SUNDRY NOTICES AND REPORTS ON WELLS
Do not use this form for proposals to drill or to re-enter an abandoned well. Use Form 3160-3 (APD) for such proposals.

8. Well Name and No.
C.H. LOCKHART FEDERAL NCT-1 #8

9. API Well No.
30-025-12131

Job: Add Perfs Using Baker STIM-GUN And Install Larger Injection Tbg

WELL DATA SHEET

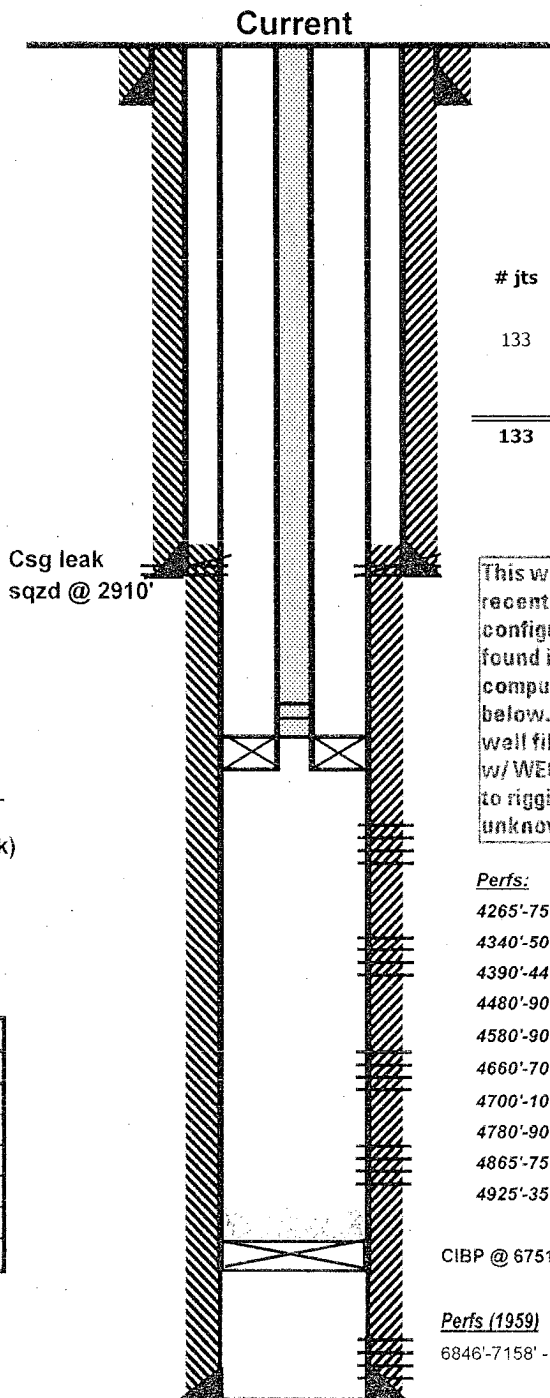
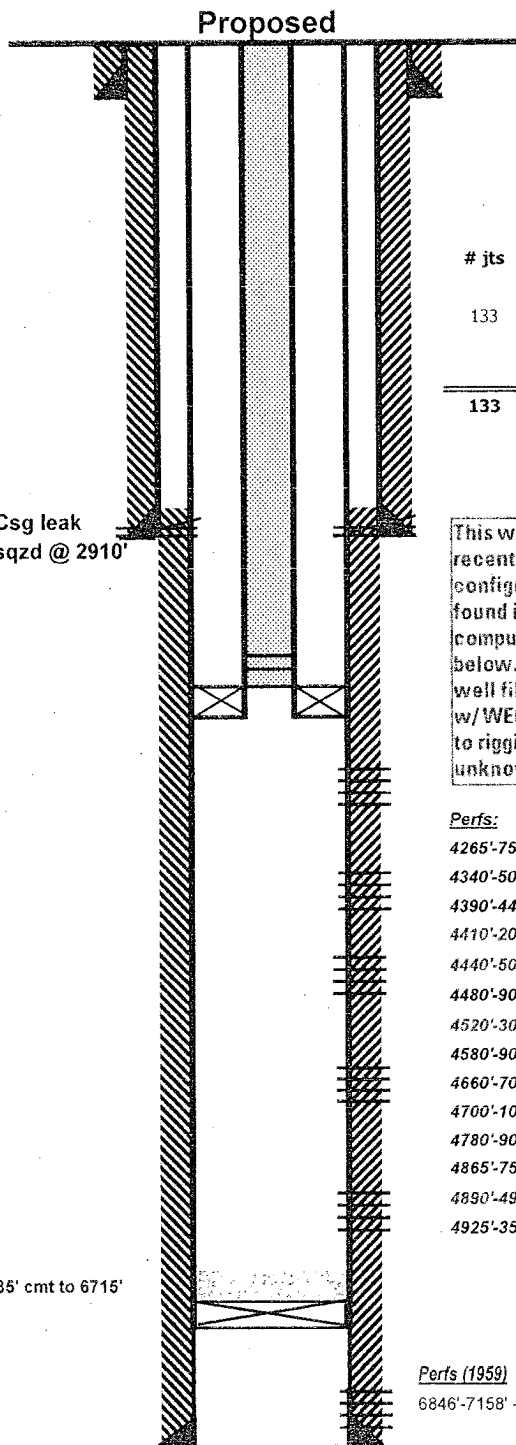
CHEVRON U.S.A. INC. INTENDS TO ADD PERFS USING A STIM-GUN & INSTALL LARGER INJECTION TBG STRING.

# jts	Tubing Detail:	Length
	KB to Hanger Distance	12.00
133	3-1/2" EUE 9.3# J-55 IPC Tubing	4193.30
	On-Off Tool w/ 2.25" "F" Profile	1.70
	Arrowset 1-X NP Packer	7.68
133	End of Tubing ==>	4214.68

Perfs:	Status:
4265'-75'	San Andres - Open
4340'-50'	San Andres - Open
4390'-4400'	San Andres - Open
4410'-20'	San Andres - Open
4440'-50'	San Andres - Open
4480'-90'	San Andres - Open
4520'-30'	San Andres - Open
4580'-90'	San Andres - Open
4660'-70'	San Andres - Open
4700'-10'	San Andres - Open
4780'-90'	San Andres - Open
4865'-75'	San Andres - Open
4890'-4900'	San Andres - Open
4925'-35'	San Andres - Open
